**Draft Environmental and Safety  
Analysis of a Proposed Low-Level  
Radioactive Waste Disposal Facility in  
Andrews County, Texas**

**August 2008**

**Radioactive Materials Division**

**TEXAS COMMISSION ON ENVIRONMENTAL QUALITY**

Figure EA-3: TCEQ Suggested Facility Operations Pyramid

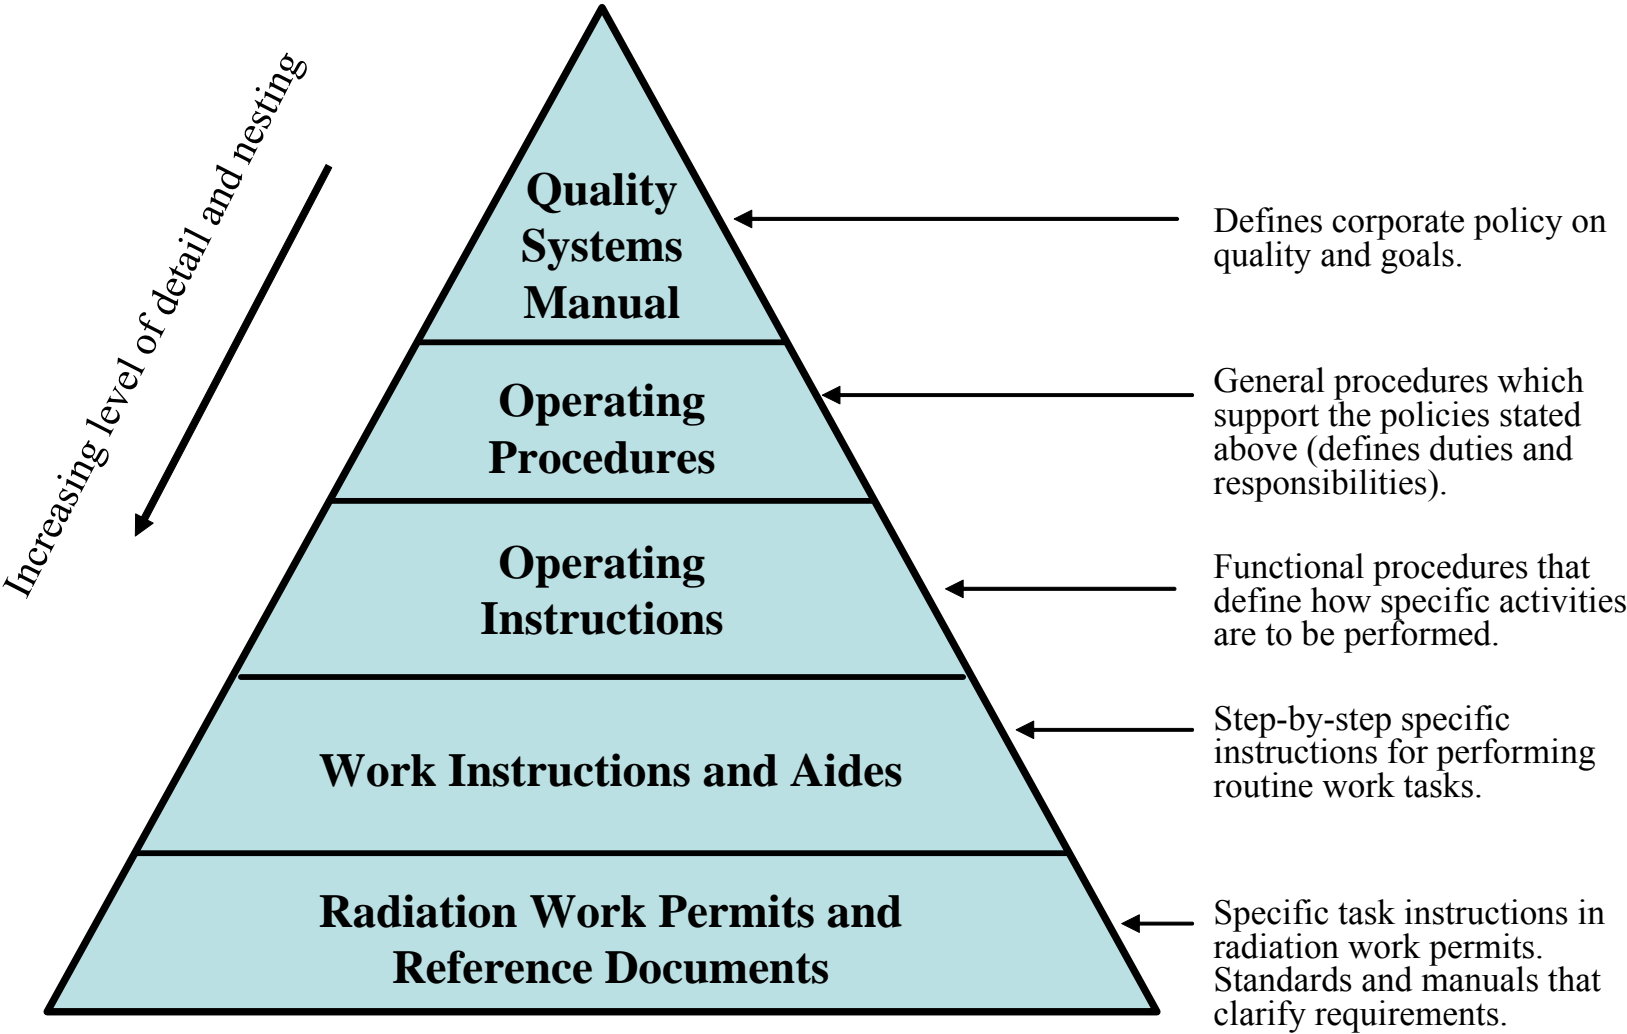
There is no mention in the procedures in the application that routine review and updates of the operational standards will be conducted. The Executive Director recommends that procedures and instructions be routinely reviewed to ensure they reflect the most current conditions. Operational programs should be continuously subject to improvement. Procedures should be reviewed and adjusted to improve operations and worker safety. The responsibility for updating each procedure, document control, and maintenance must be clearly defined. When a procedure is updated, processes and responsibilities for operator training must be clearly defined and documented. Backups for key operating personnel as well as chain of command during normal operations and emergencies should be clearly defined in the procedures.

**Figure EA-4: Conceptual Cross-Section of the Proposed Disposal Facility**

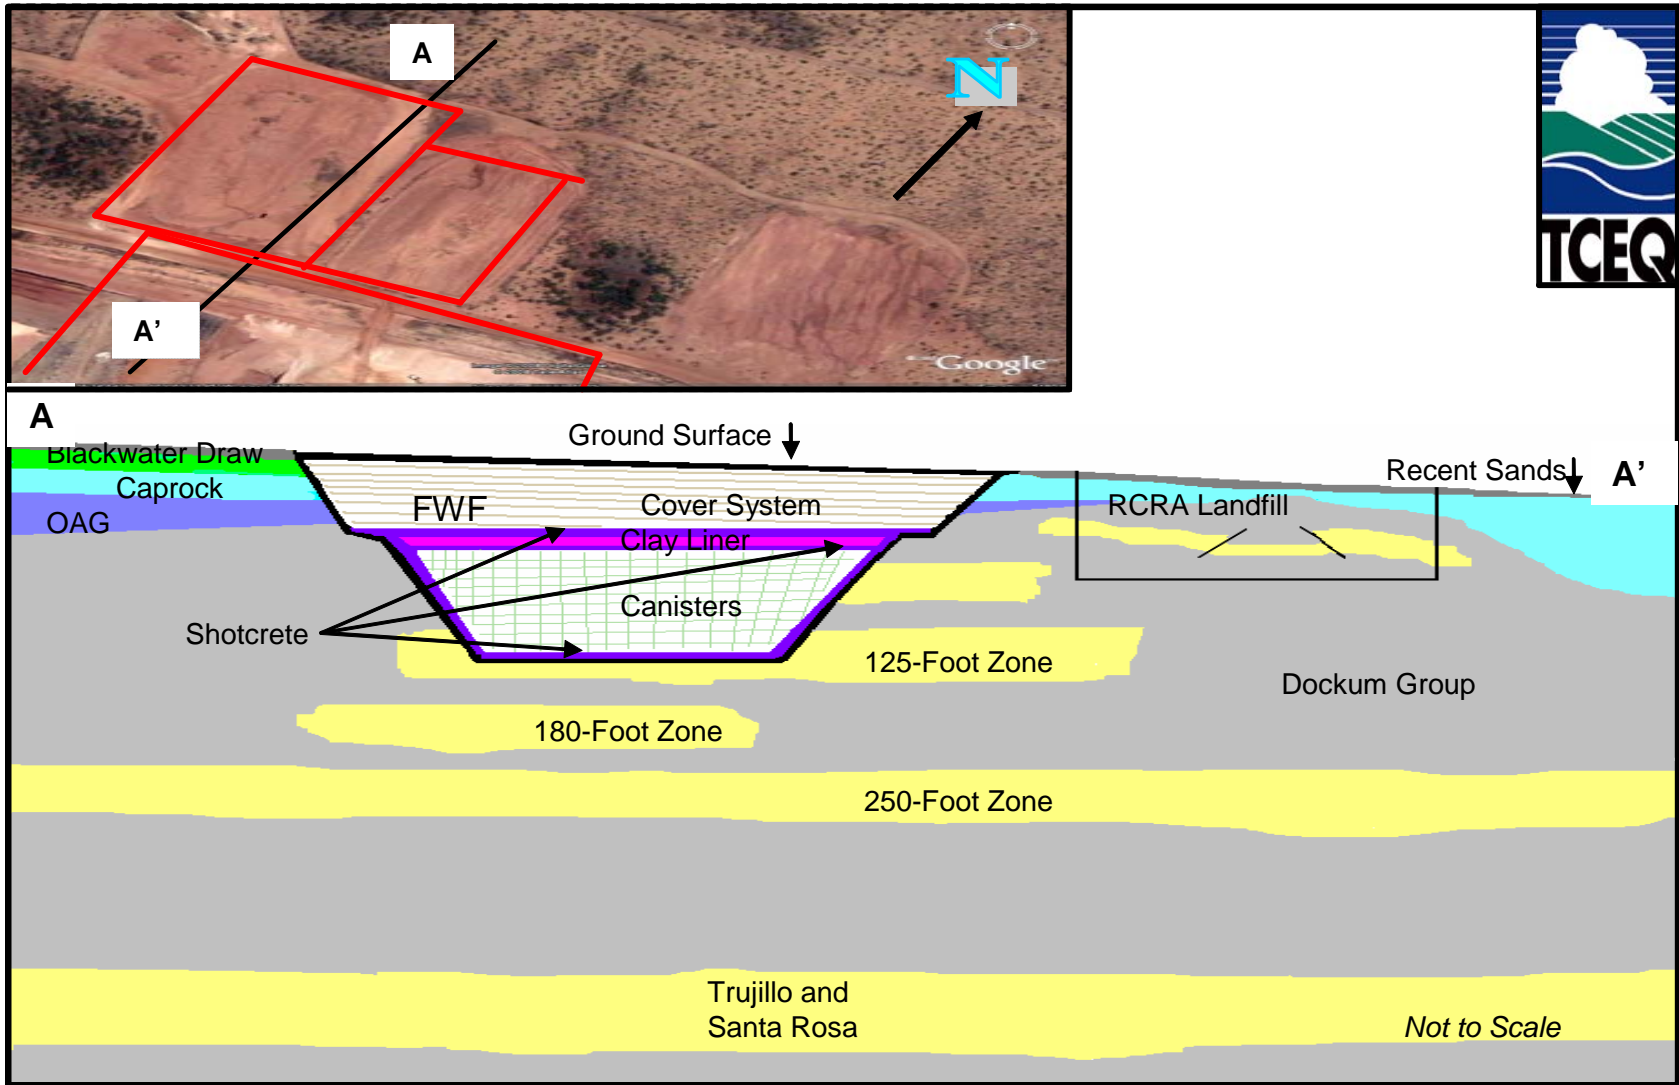
According to TCEQ and BEG staff reviews, there appear to be correlation errors on cross-sections A-A', B-B', C-C' and E-E' in Appendix 2.6.1 of the application. On cross-section A-A', between wells B48 and TP04/PM06, there is approximately 50 feet of difference in elevation of the 225-foot zone between these two wells, which are only about 2,500 feet apart. Similarly, the cross-sections indicate approximately 50 feet of elevation change along the bottom of the 225-foot zone between wells B-48 and TP-04/PM-06. In addition, up to 55 feet of elevation difference along the top and bottom of the siltstones described as the 225-foot zone between wells A-22 and TP-04, which are approximately 4,500 feet apart has been noted. The siltstones and sandstones of the 225-foot zone in wells B-48, TP-04, and A-22 are only approximately 21 feet thick. It would be unusual to have 50 feet of elevation difference in a single stratigraphic unit comprised of siltstones and fine sandstones over a horizontal separation of only 2,000 to 4,500 feet. It is possible that the 225-foot zone is not a single depositional unit as is implied by the structure maps (Figures 5-11 and 5-12) and the cross-sections A-A' and B-B' (Figures 6-5a and 6-5b) provided in the Appendix 2.6.1 of the application.
